SEPTEMBER 19TH 2019 TO JANUARY 2022
TECHNICAL BULLETIN TECH077
FULL DISTRIBUTION

Replacement of turbo part family 789500 as used on FPT applications

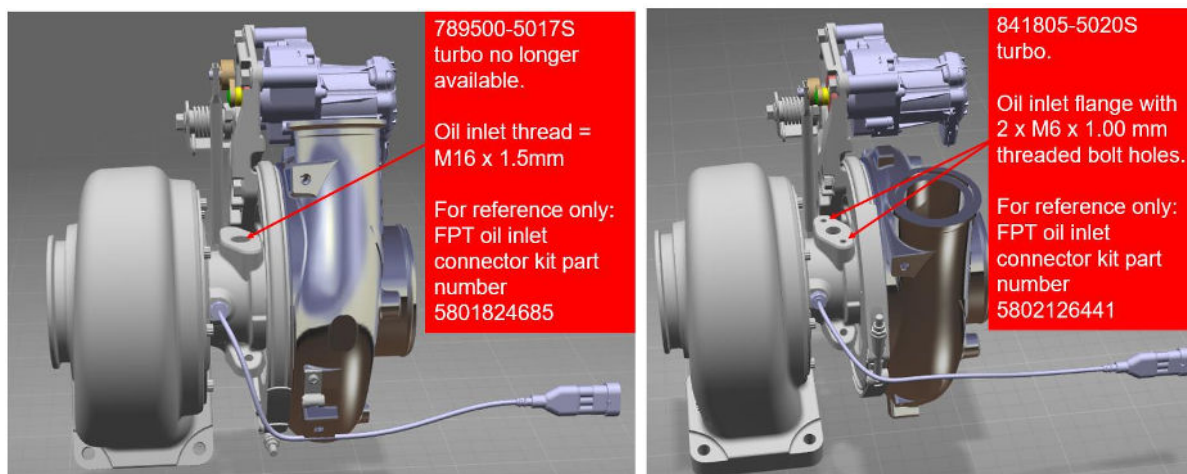
The production of turbo part family 789500-5XXXS has finished and it will be replaced by turbo part family 841805-5XXXS which has a different oil inlet configuration.

This means that to replace an turbo from part family 789500-5XXXS to an turbo from part family 841805-5XXXS it is necessary to also replace the oil inlet pipe kit which is an OEM part

Original TC PN	Replacement TC PN	Comments
789500-5008S	841805-5011S	oil inlet changed from M16 to 2 x M6 bolts, new FPT inlet pipe PN 5802126419 KA (Off Road application)
789500-5017S	841805-5020S	oil inlet changed from M16 to 2 x M6 bolts, new FPT inlet pipe PN 5802126441 KA (Off Road application)
789500-5018S	841805-5014S	oil inlet changed from M16 to 2 x M6 bolts, new FPT inlet pipe PN 5802126447 KA (Off Road application)
789500-5020S	841805-5015S	oil inlet changed from M16 to 2 x M6 bolts, new FPT inlet pipe PN 5802126409 KA (On Road application)
789500-5021S	841805-5018S	oil inlet changed from M16 to 2 x M6 bolts, new FPT inlet pipe PN 5802126462 KA (Off Road application)
789500-5024S	841805-5011S	oil inlet changed from M16 to 2 x M6 bolts, new FPT inlet pipe PN 5802126419 KA (On Road application)
